**Failure Modes and Effects Analysis
(FMEA) of the ICS/NNI Electric Power
Distribution Circuitry at the
Oconee 1 Nuclear Plant**

A. F. McBride
C. W. Mayo
R. E. Battle

Manuscript Completed: August 1985
Date of Issue: October 1985

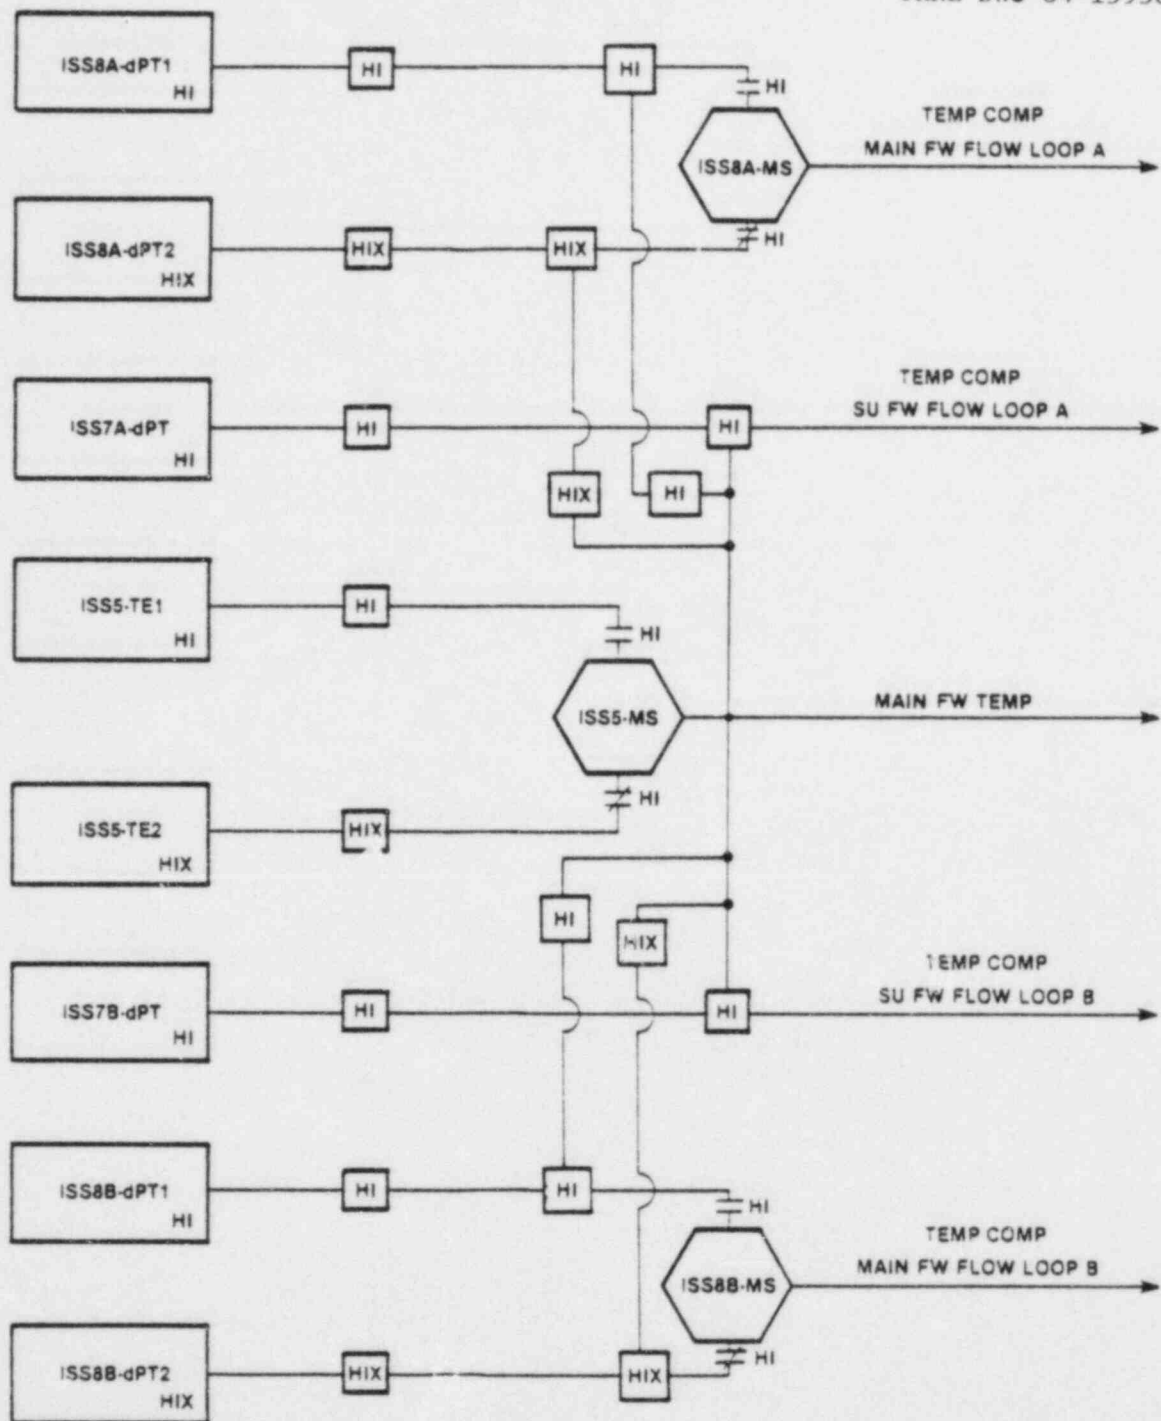
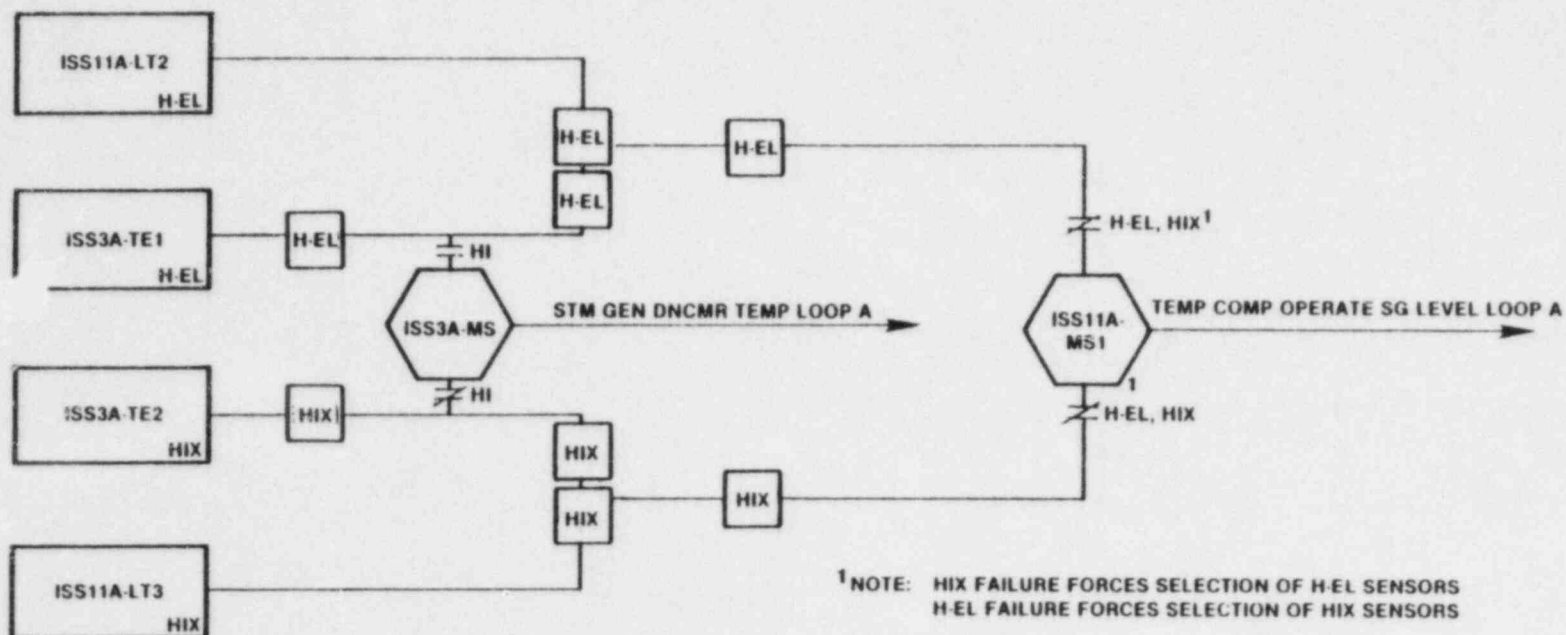
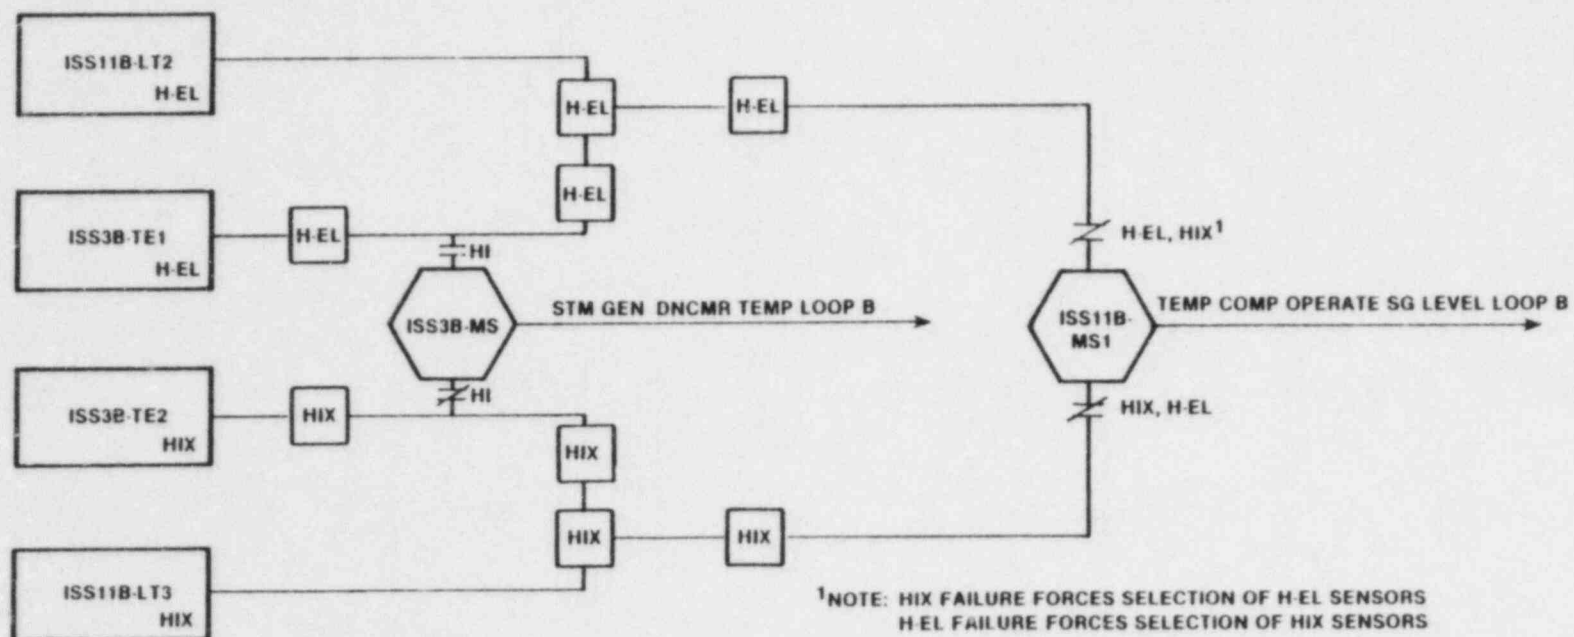
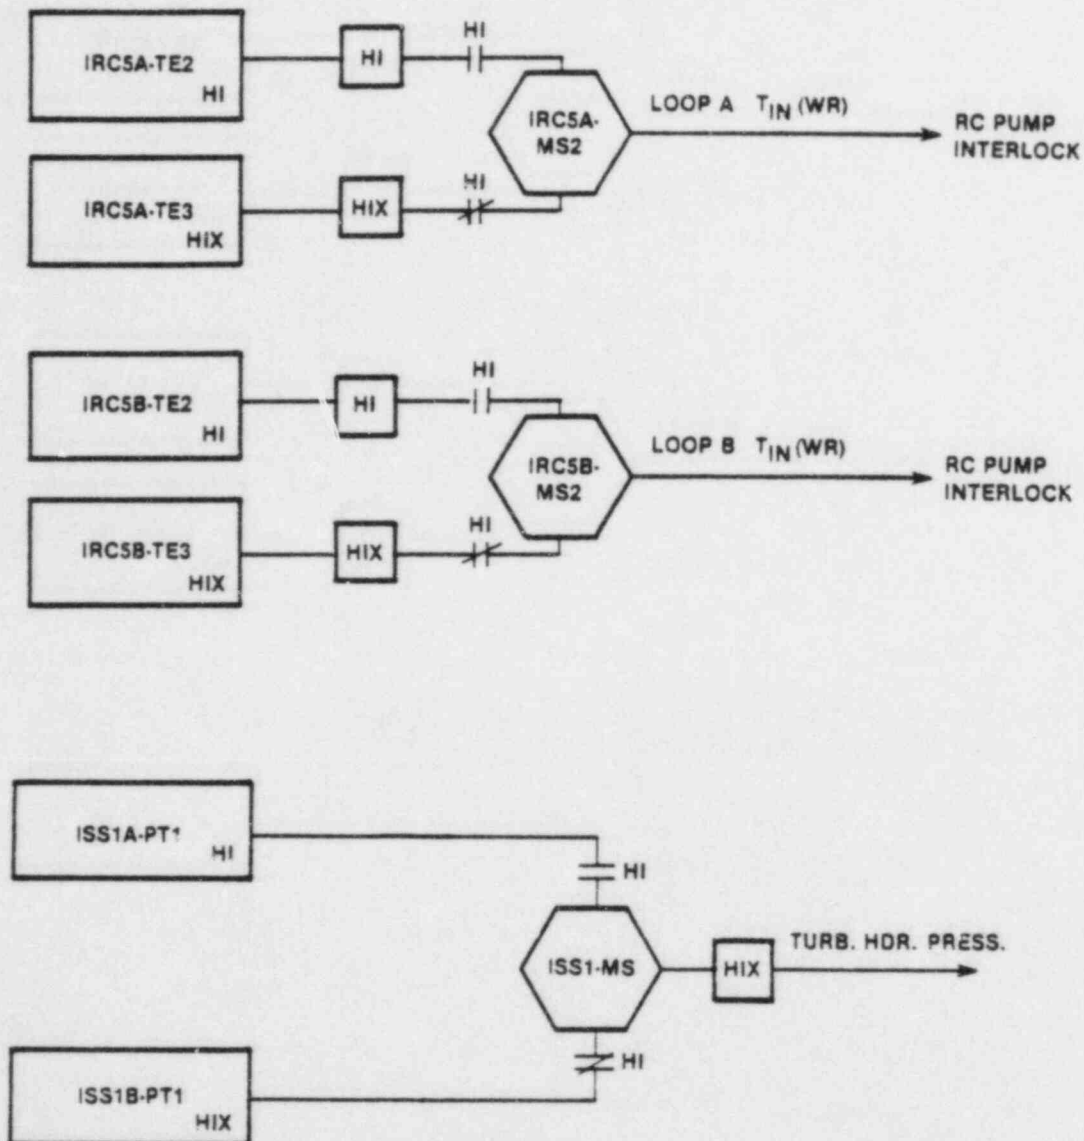
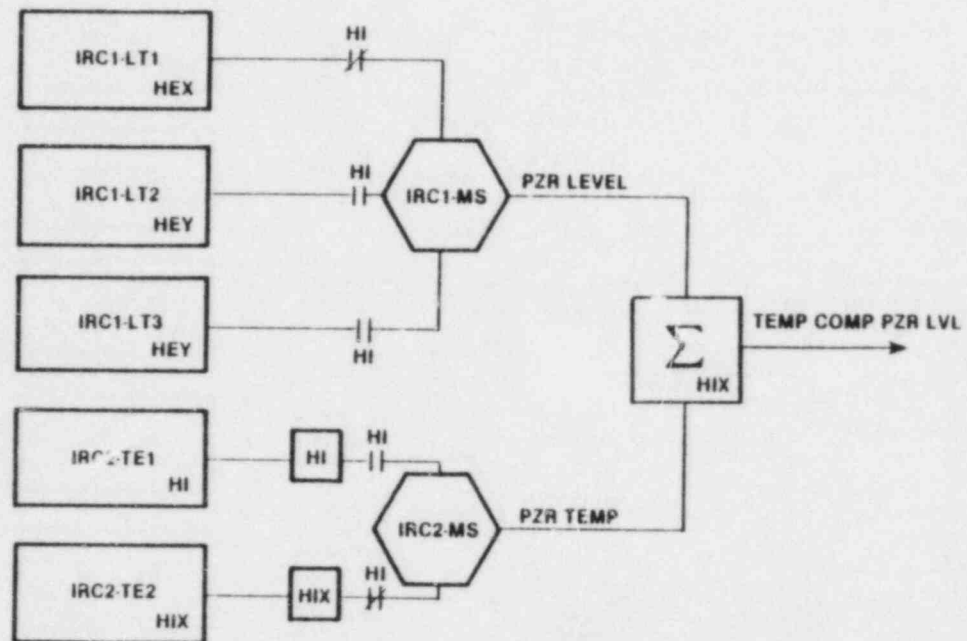
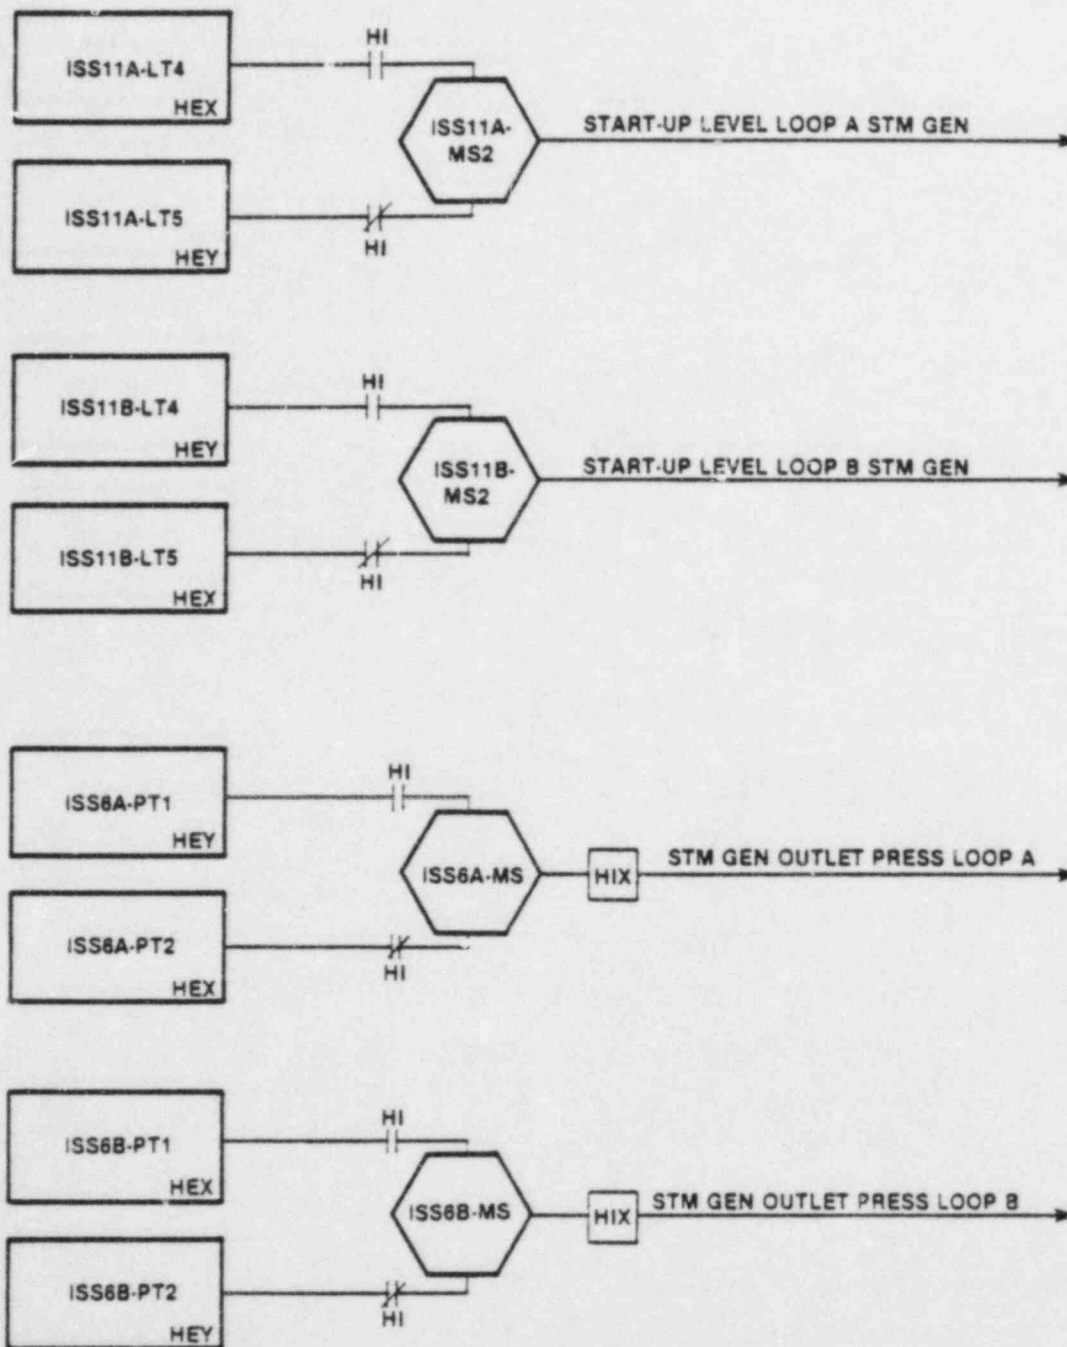
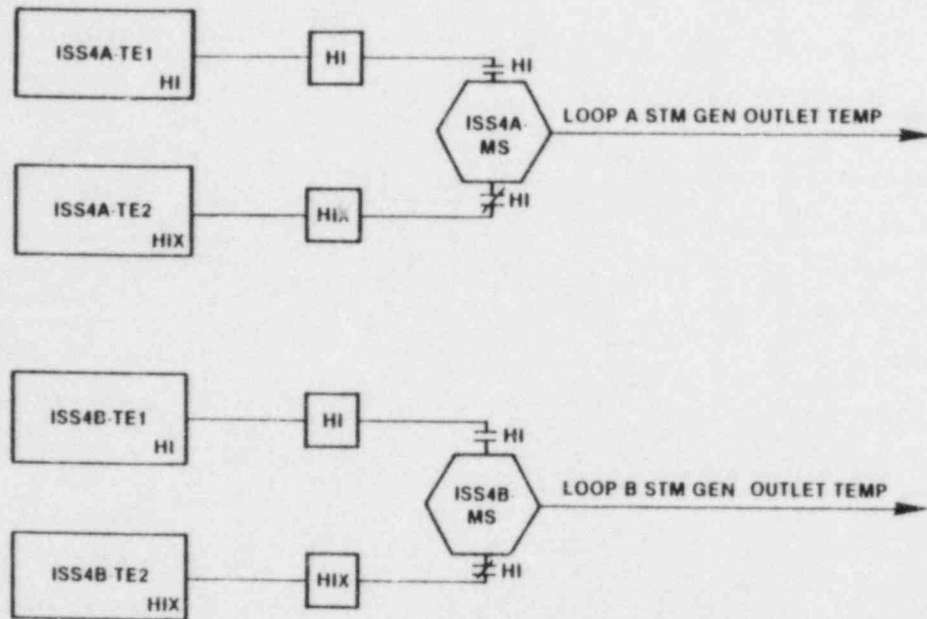
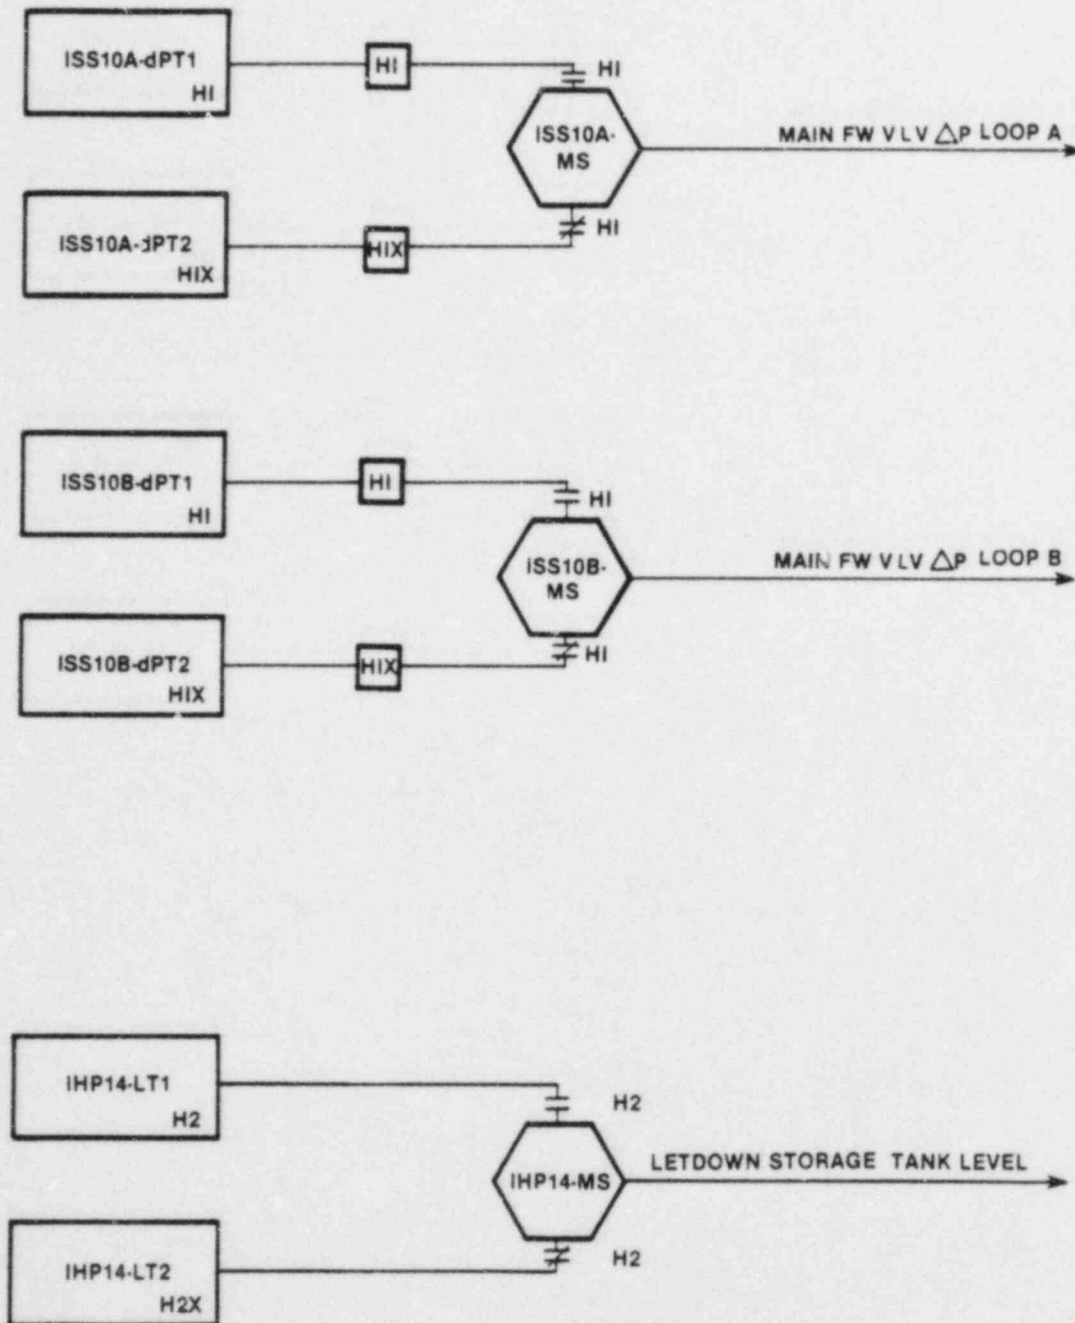
Comment 5: A key to the symbols in Figs. 3.1 through 3.9 would be helpful.
